**BEFORE THE PUBLIC UTILITY COMMISSION  
OF OREGON**

**LC 57**

2013 Integrated Resource Plan

STAFF'S FINAL COMMENTS

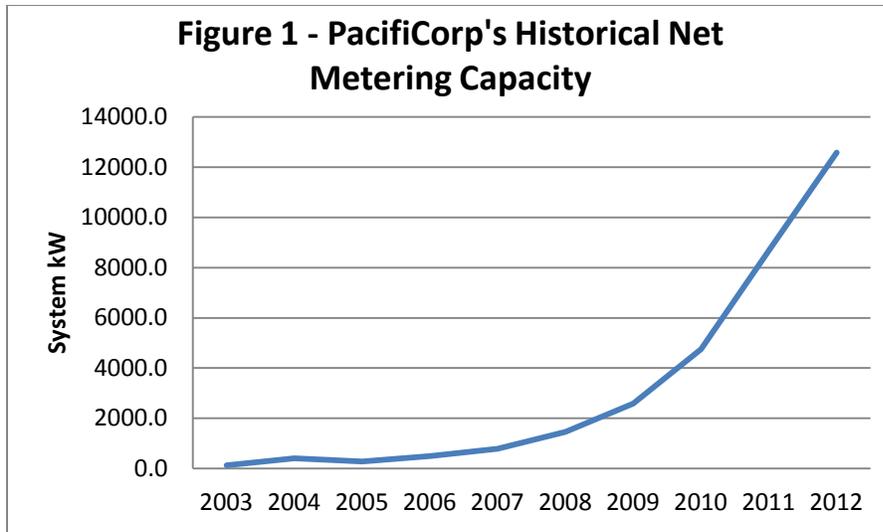
Staff is concerned that the Company's modeling is not adequately accounting for potential future load reductions due to net metering. Numerous industry articles have identified net metering as a threat to the viability of traditional utility structures. PacifiCorp's own data indicate that net metering capacity has followed a rapid exponential growth curve over the last several years. PacifiCorp claims that their forecast methodology accurately anticipates net metering growth, and that because of this the Company does not need to account for net metering growth in the IRP. Staff looked at this in detail and disagrees with both of these positions.

Figure 1 below plots PacifiCorp's historic growth in net metering. Currently, at 12 megawatts, net metering represents a relatively small portion of PacifiCorp's demand. However net metering is growing at approximately 40 percent annually. As the market matures, prices will continue to decrease. However, a federal tax credit that is currently supporting this growth is set to expire in 2016. If the growth in net metering is maintained at 40 percent for 10 years, PacifiCorp's net metering capacity would be 350 MW by 2023.

## Appendix D - Natural Gas prices in PaR

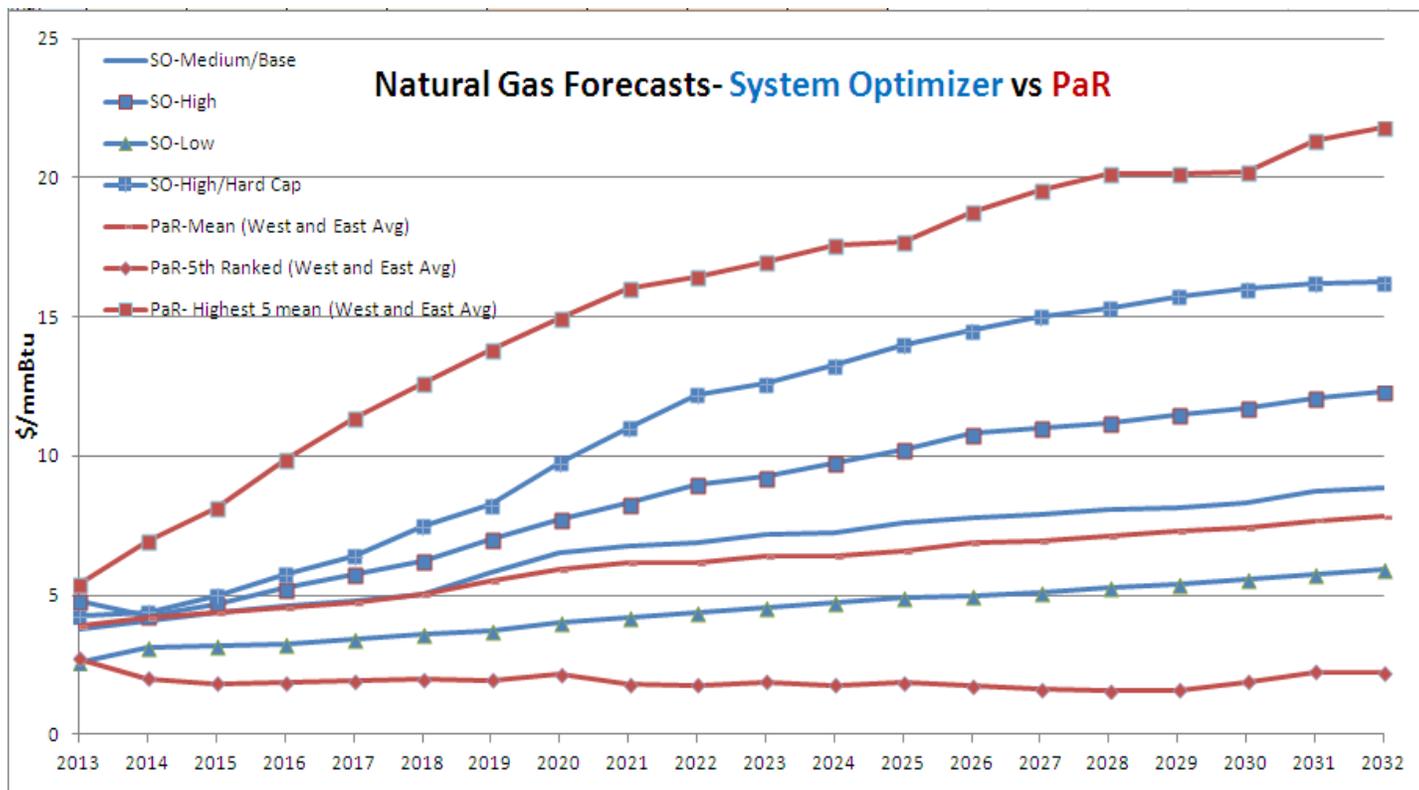
Staff believes that Natural gas prices have proven to be the most important driver of portfolio choice in this IRP for the following reasons:

- 1) In PacifiCorp's modeling natural gas prices are dependent upon and highly correlated with CO<sub>2</sub> prices
- 2) Natural gas prices determine wholesale electricity prices in PacifiCorp's modeling, and gas and power prices are highly correlated so electricity prices track gas prices closely
- 3) Because coal prices are relatively stable (and in PaR do not vary at all) the coal versus gas decision is driven mostly by variation in natural gas prices

## **Appendix E - Stochastic treatment of system load**

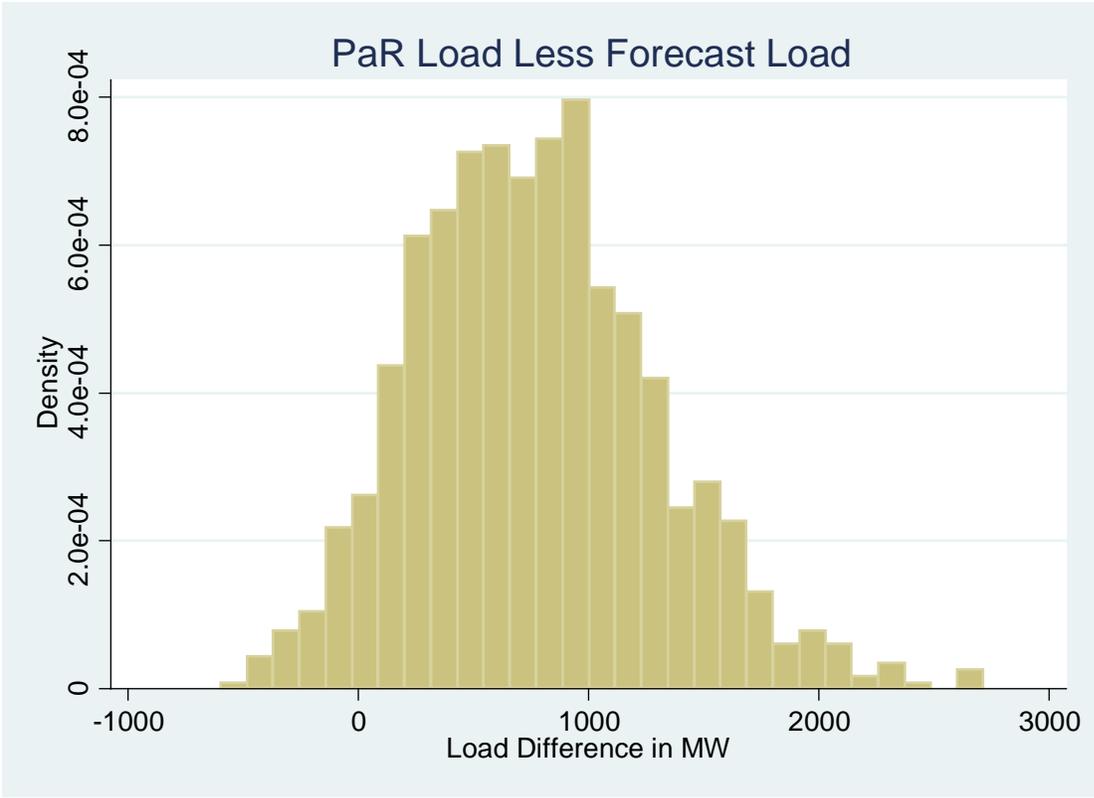
A very important factor in the evaluation of the proposed portfolios is the reliability of the system. Energy not served is modeled as increased system costs. The company also separately examines the amount of energy not served in Tables 8.3 and 8.4 and Figure 8.24 of Volume 1. These numbers are grossly overestimated due to the manner in which the Planning and Risk model perturbate loads. The PaR model simulates 100 futures, each with different loads. The response to OPUC DR 73 provides the stochastic load parameters used for each future. Each future is independent. This means that the load parameter in any period from one future is uncorrelated with the load parameters for the same period in all the other futures. The loads are calculated individually for each jurisdiction. Staff aggregated the individual jurisdiction loads into a sign load parameter by weighting each jurisdictional load factor by the jurisdiction's contribution to system peak.

Staff generated the perturbed system loads for each future by multiplying the hourly load forecast from the confidential response to OPUC DR 278 with the associated load parameter. This changed the day on which the system peak occurred because some futures had a low load parameter on the day of the forecasted peak, but a high load factor on a day with near peak loads. Because of this, nearly all futures had peak loads significantly higher than forecasted load. The Figure below provides a histogram of the difference between the PaR peak loads and the forecast peak loads between 2013 and 2022. The distribution should be centered around zero. In fact, on average PaR annual peak loads are 770 MW higher than the forecasted peaks. This effectively reduces the Planning and Reserve Margin from 13 percent to 7 percent when portfolios are evaluated in the PaR model. Approximately 14 percent of all years evaluated in PaR have peak loads that exceed the planning and reserve margin. The result of this is inflated costs for all portfolios, and an over estimation of energy not served for all portfolios. The company provides energy not served results only from the PaR modeling. An important consequence of this is that, in PaR results, overbuilt portfolios appear to be resource stressed.
